# E C O L O G I C A L   R E V I E W

**Grand Lake Shoreline Protection**  
CWPPRA Priority Project List 11  
State No. ME-21

September 14, 2004

This document reflects the project design as of the 95% Design Review meeting, incorporates all comments and recommendations received following the meeting, and is current as of September 14, 2004.

Figure 2: Typical dike section (USACE 2004).

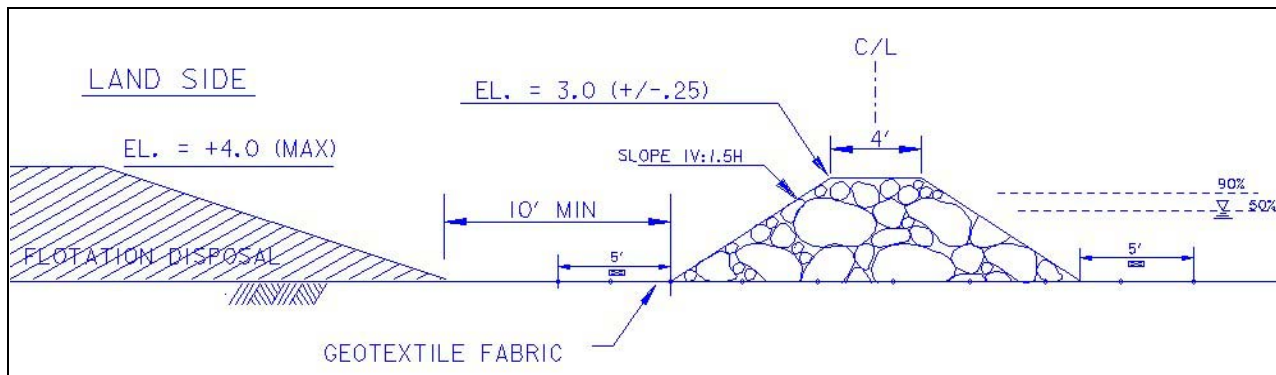
Originally the crest elevation of the shoreline protection structure for the Grand Lake project was designed at +3.5 feet NAVD-88 which was calculated by adding the following three factors: mean water elevation, 90% wind setup, and 90% wave height. However, protecting against 90% of the wave height was considered a conservative estimation of the conditions in the Grand Lake project area. Project engineers felt that designing the rock dike to protect against  $\frac{1}{2}$  of the 90% wave height would reduce the cost and overall pressure on the soil foundation while still providing adequate shoreline protection. As a result, the current structure elevation design of +3.0 feet NAVD-88 was determined through the addition of the Grand Lake mean water level (+1.45 feet), 90% wind setup (0.50 feet), and  $\frac{1}{2}$  of the 90% wave height (0.85 feet). This design technique results in 0.2 feet of the rock dike remaining sub-aerial during storm conditions.

Figure 3. Time settlement curve for proposed Grand Lake foreshore rock dike after construction.

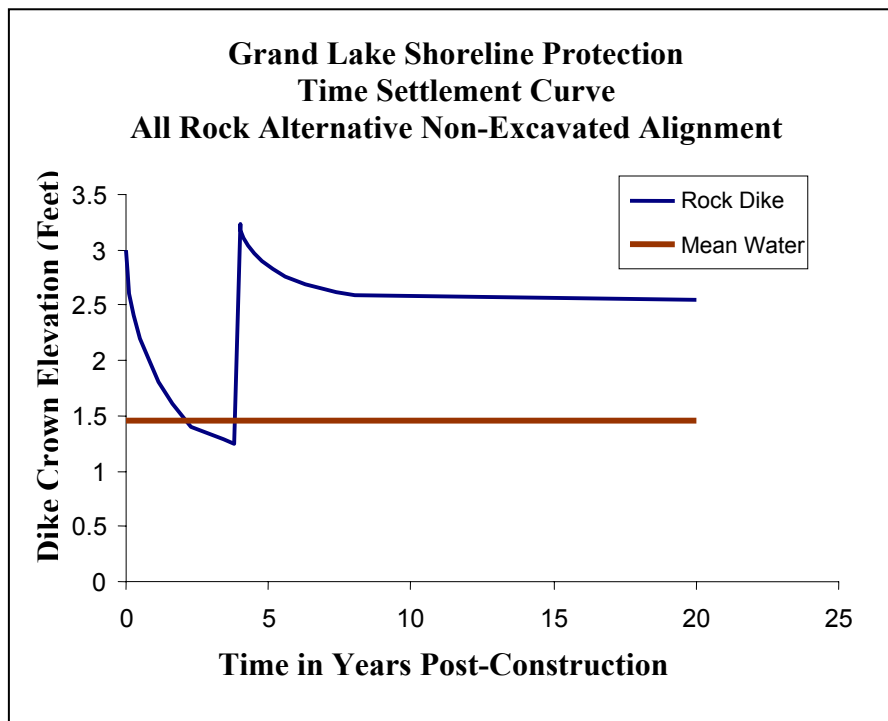
According to the settlement consolidation curves, the structure elevation will fall below mean water level (+1.45 feet NAVD-88) two years post-construction, one full year before the scheduled maintenance lift planned for year three (Figure 3). It is conceivable that once submerged the foreshore rock dike will become somewhat less effective as a shoreline protection structure, and a possible threat to navigation. However, project team members determined that the benefits of the shoreline protection structure would not be significantly reduced in view of the fact that the structure would be submerged for a relatively short period of time. In addition, the dredged material placed on the landward side of the rock dike would offer further protection to the Grand Lake shoreline. To avoid possible threats to navigation, the structure will be adequately marked.

NAVD-88), one year prior to the scheduled maintenance lift (year three). However, the structure will be submerged for a relatively short period of time before the scheduled lift at year three is implemented and it was determined by the project team that the benefits of the project would not be significantly reduced. In addition, the dredged spoil placed landward of the structure during construction will offer additional protection to the Grand Lake shoreline.
